RE: PLUS review 2013-08-04, Showfield

In regard to the above referenced project and pursuant to your comment letter dated 25 September 2013, please find the following point by point response in [blue](#) for your review.

Showfield (PLUS 2013-08-04)

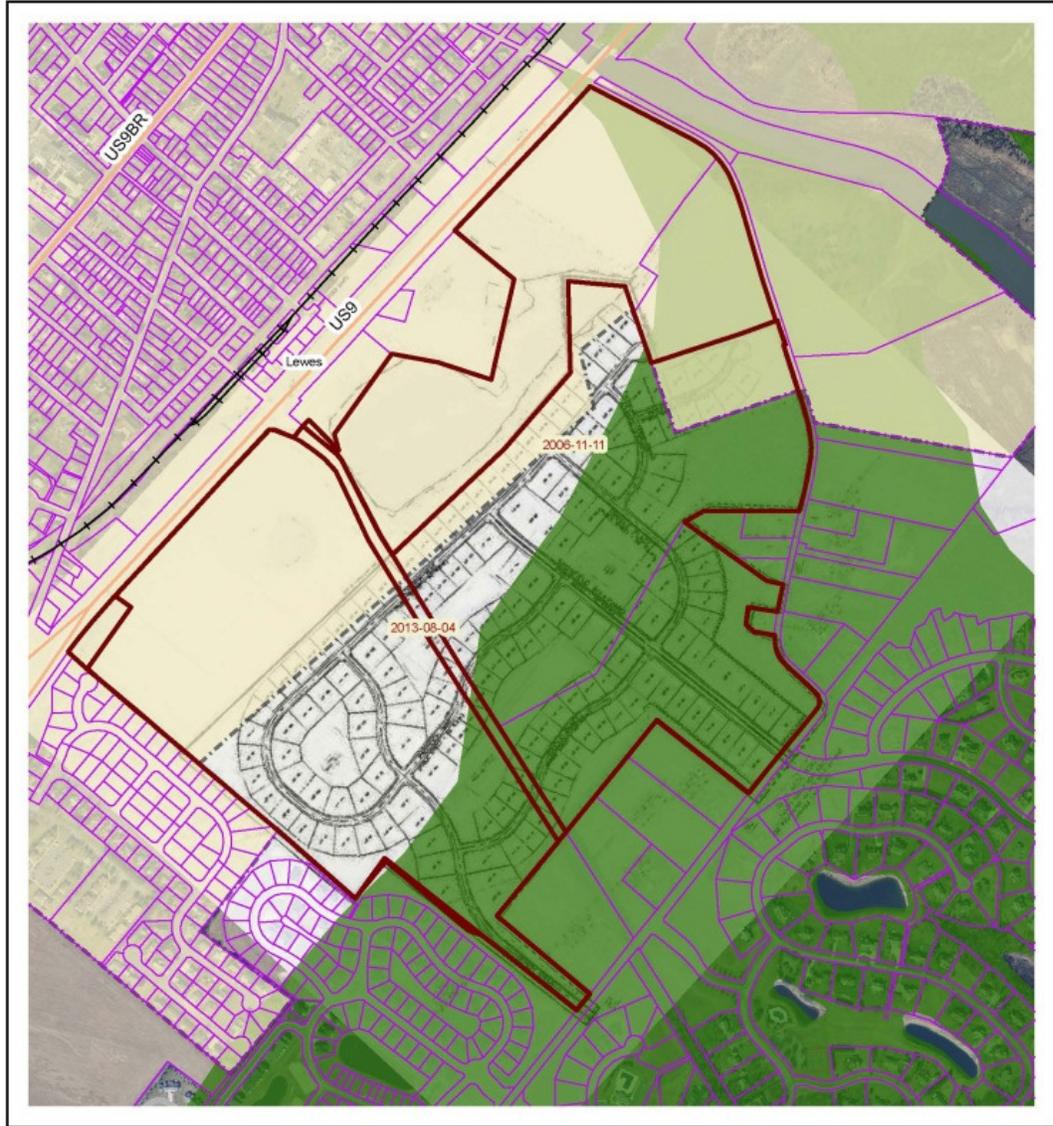
- A significant portion falls within an excellent ground-water recharge potential area for the Sussex County (see attached map). Sussex County has source water protection ordinance in place.

The applicant indicates that wet ponds are anticipated for the management of stormwater. Wet ponds intersect the water table and have the potential to affect the water quality of the aquifer. Some research suggests that pollutant removal is reduced when ground water contributes substantially to the pool volume (Schueler, 1997).

- DNREC recommends:
 - Limiting impervious cover to 35 to 60 percent,
 - Quantify recharge to demonstrate post-development recharge is greater than or equal to pre-development recharge using the elements outlined in Sussex County Source Water Protection Ordinance No. 1979 §89-7, A. (2).
 - Wet ponds should be located outside the excellent ground water recharge potential area
 - In addition, because the excellent ground water recharge area can readily affect the underlying aquifer if contaminants are spilled or discharged across the area, the storage of hazardous substances or wastes should not be allowed within the area unless specific approval is obtained from the relevant state, federal, or local program.

Our office has met with the Sussex Conservation District and has held the required pre-submittal meeting. The existing excellent groundwater recharge areas on the site were discussed with the District as well as the proposed intent for onsite stormwater management. As construction plans are prepared the developer will continue to work with the Conservation District and DNREC to meet all local and state requirements.

Figure 1: NRCS soil survey mapping update in the vicinity of the proposed construction.

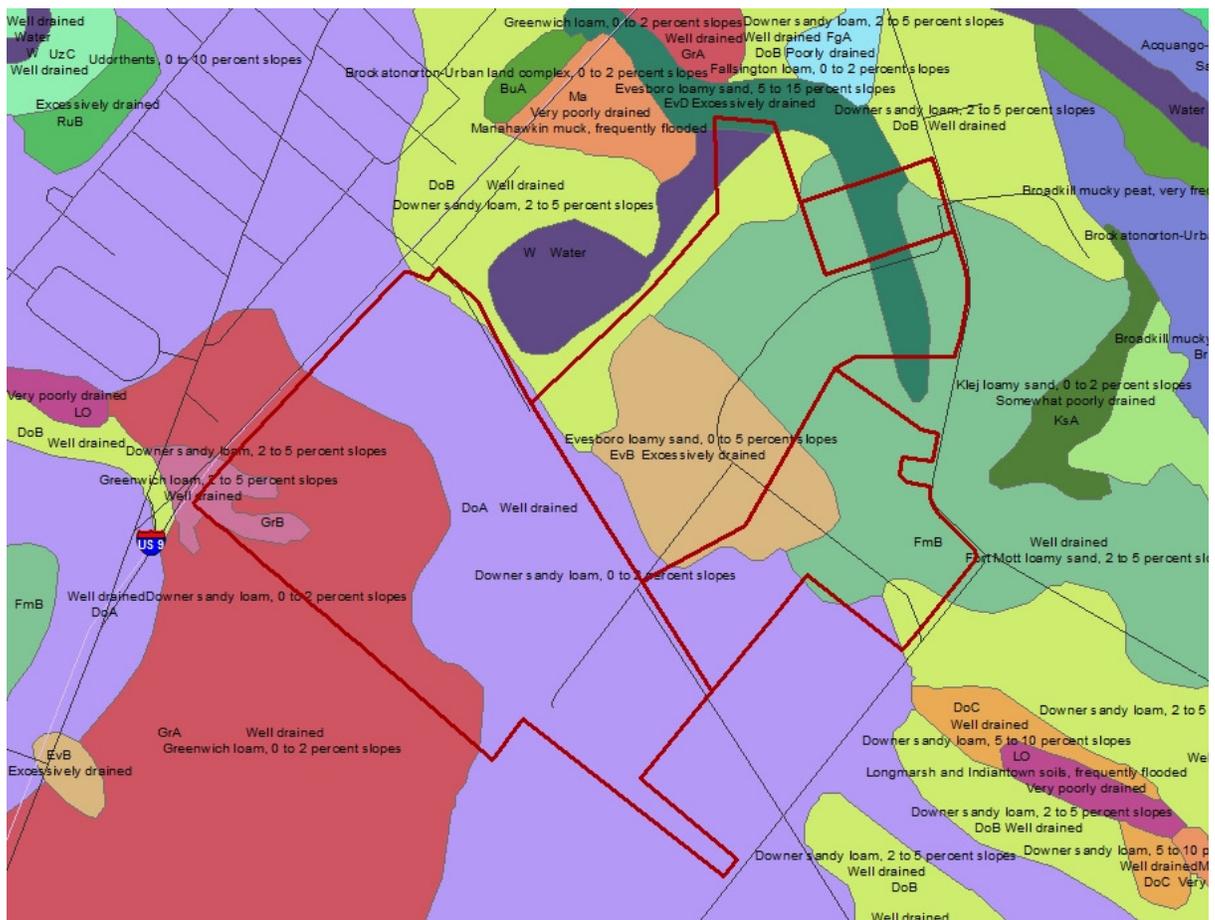
- Based on soils survey mapping update, following soil mapping units were mapped on subject parcel (grouped on the basis of drainage class):
 - Well drained – Fort Mott (FmB) and Greenwich (GrA & GrB)
 - Excessively well drained – (EvB & EvD)
 - Poorly drained (hydric) – Fallsington (FgA)
- Based on NRCS soils survey mapping update, the primary soil mapping unit of concern is Fallsington (FgA). Fallsington is a poorly-drained wetland associated (hydric) soil that has severe limitations for development (Figure 1). DNREC strongly recommends that the applicant avoid construction in the immediate vicinity of the Fallsington soil mapping unit

A field evaluation by a licensed soil scientist is strongly recommended (ARCPACS certified and licensed Class D) to make a site-specific field delineation of the hydric soils in this parcel. Please contact the Underground Discharges Branch at 739-9948 for a list of licensed soil scientists.

This office has met with the Conservation District to discuss current and proposed site conditions. As the design evolves subsurface testing, that has already been completed, will be reevaluated as necessary to meet the local and state requirements as it relates to stormwater management and runoff control.
